AMENDMENT/ADDENDUM No. 1

Solicitation Number: 2021-11RF

Description: SHS Chiller Replacement

Drawing A

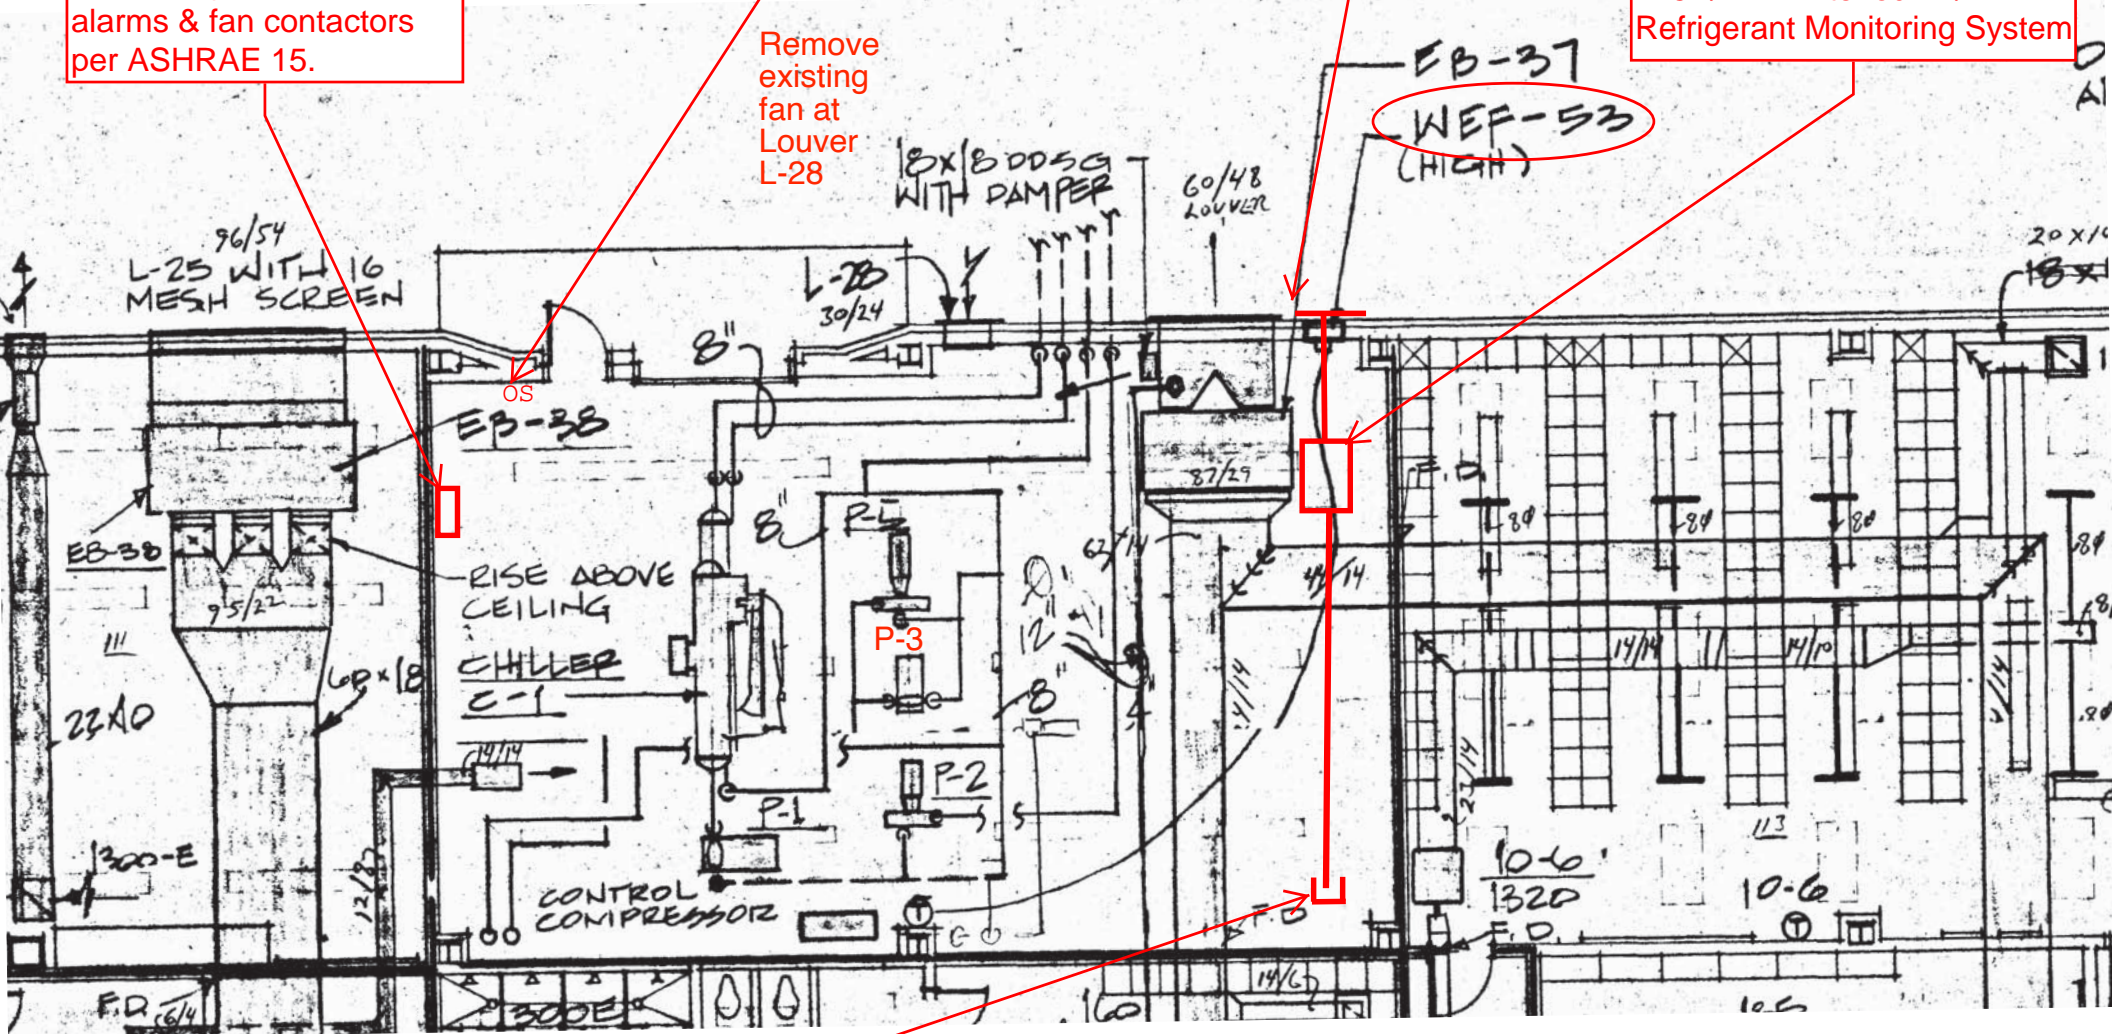
5. Under Alternate number 2, replace four base mounted chiller water pumps located in the chiller machine room. Remove the existing pumps and reconnect new to existing piping and power wiring. Pump locations are identified on the existing drawing included as part of the Addendum. Pump schedule is as follows:

6. Under Alternate number 3, remove the existing insulation on the chilled water and condenser water piping and install new. The existing drawing attached shows pipe routing. Photos of the mechanical room are included to clarify the extent of existing piping.

New occupancy sensor: wire in parallel to exist. T'stat so that exist. WEF-53 operates any time room is occupied.

New Refrigerant Monitoring System with alarms & fan contactors per ASHRAE 15.

New Hurricane Exhaust Louver: Ruskin ELF6375DXD, 32"x32", 4.19 Sq. Ft. Free Area, 2,500 CFM, Kynar Finish, Color Selected by Owner

New EF-1: Greenheck SQ-140-VG, 2,500 CFM @ .25" SP., 3/4 HP EC Motor, 115V/1PH. Interlock w/ Refrigerant Monitoring System

Remove existing fan at Louver L-28

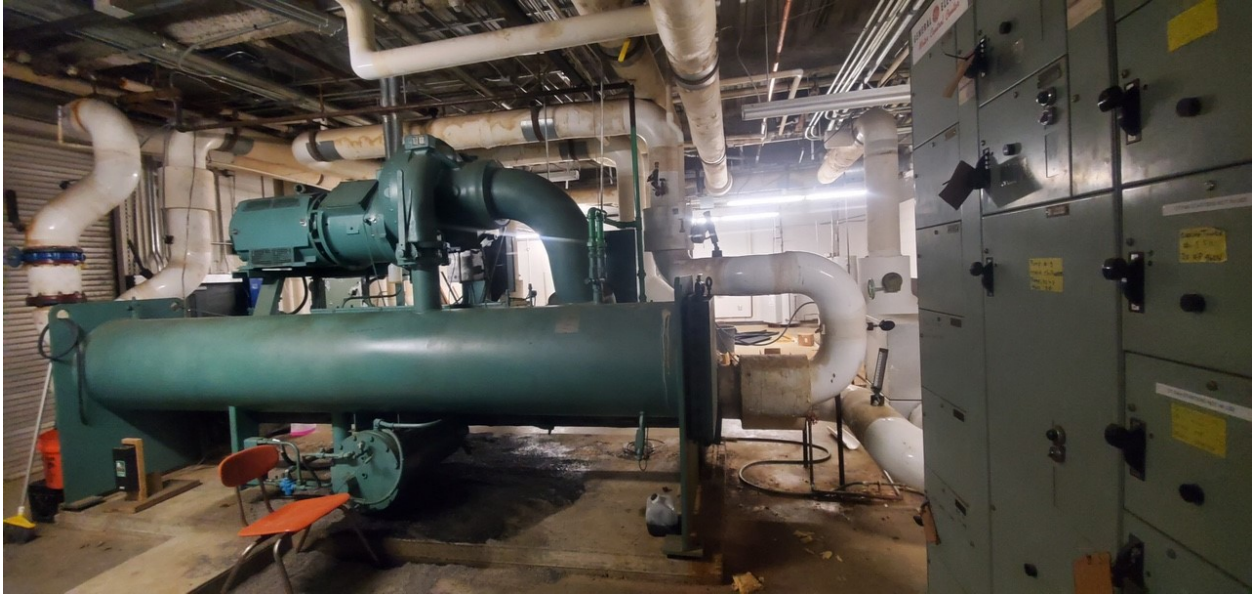
20X20 Exhaust duct: turn down and terminate with expanded metal grille on end, 24" above finished floor.
